工程指示 / 要求簡箋(E.I.)

工程指示編號：EI / 2921 / 21 修改版次：-
 工程編號 : J - 852 工程名稱 : 亞皆老街中電
 工程項目 : 佛沙窗 師父板 (3rd)
 收件人 : 生統 / 王良 發件人 : Ant Yeung 日期 : 07/01/2021

請按加工圖生產佛沙窗師父板 (收貨用)

Site Inspection Report # 06

Photo #13

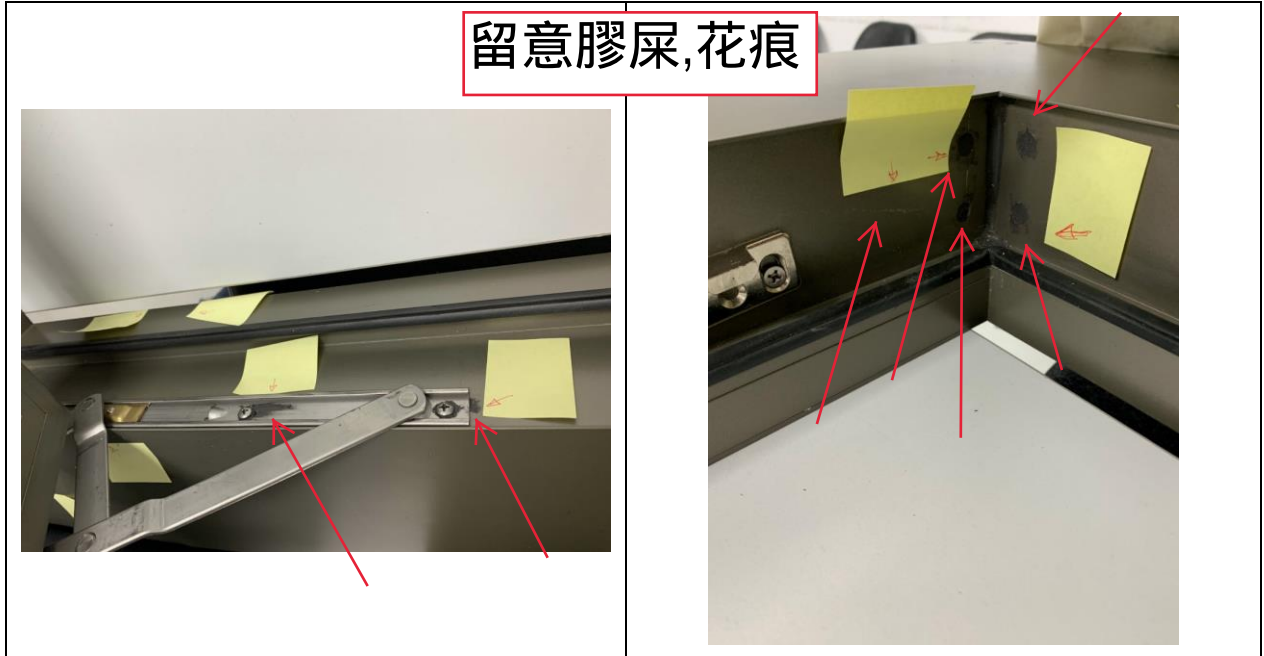
<p>Observation (Alum Window)</p>	<p>In general, no rectification works could be observed to address the observations/comments given by MFT during 1st joint inspection on 7th Aug 2020 (Details refer to report ref. no.: 1980045.1MFHK-SI-PRT-003-00, Photo #14 – Photo #36).</p>
<p>Recommendation</p>	<p>Midi is requested to address the observations/comments mentioned in the above inspection report case by case.</p>

Photo #14

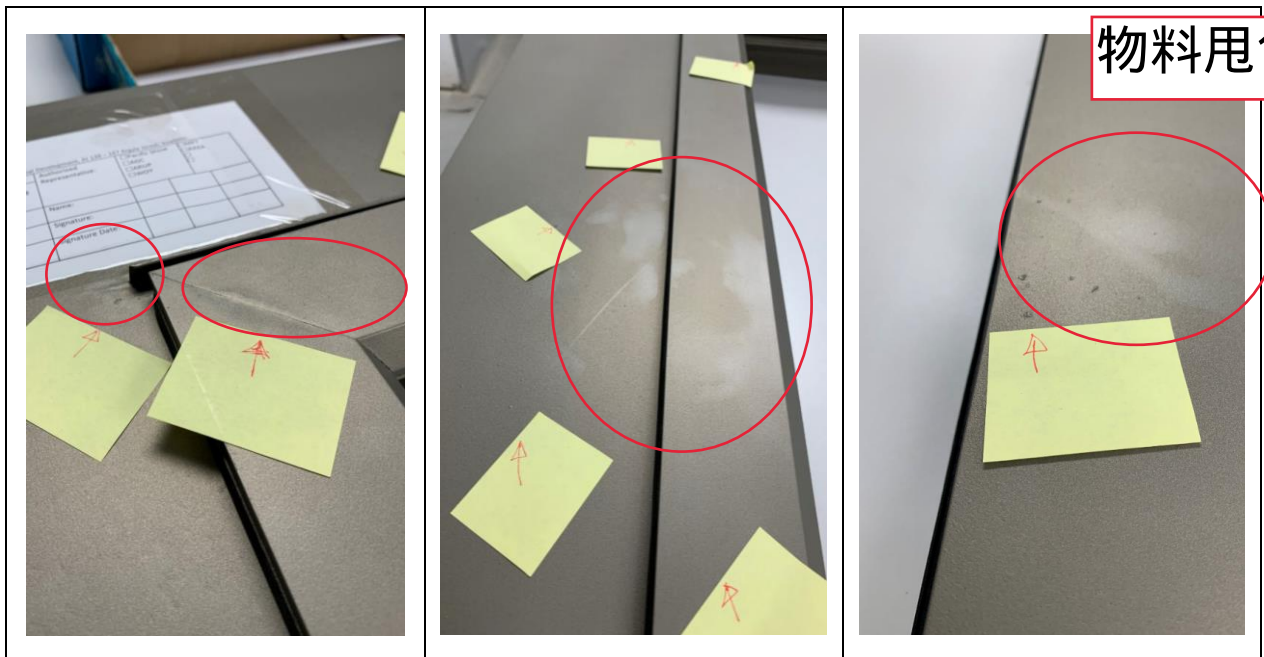
<p>Observation (Alum Window)</p>	<p>Further to Photo #13, noticeable touch-up works were also observed for the whole window sample especially at the locations with mitre joints.</p>
<p>Recommendation</p>	<p>Workmanship for touch-up works should be improved. Midi is required to rectify and resubmit the window sample immediately.</p>
